TECHNICAL SERVICE BULLETIN

NO. 72 A 3

'O' Ring Diameter
Choke Unit
S.U. H.I.F. Carburetor

1972 MGB and MGB/GT

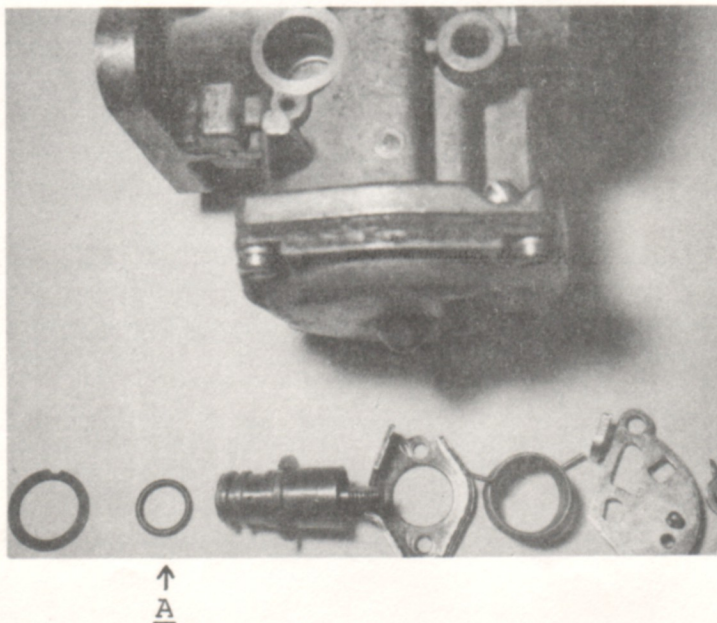
Isolated cases have been reported of the wrong size 'O' ring having been fitted to the rotary choke unit body on production. This creates an uncontrollable rich mixture, very uneven running and should be evident almost immediately on new cars.

The correct 'O' ring, part number AUD 3602 with an outside diameter of 9/16" is illustrated below (Item A).
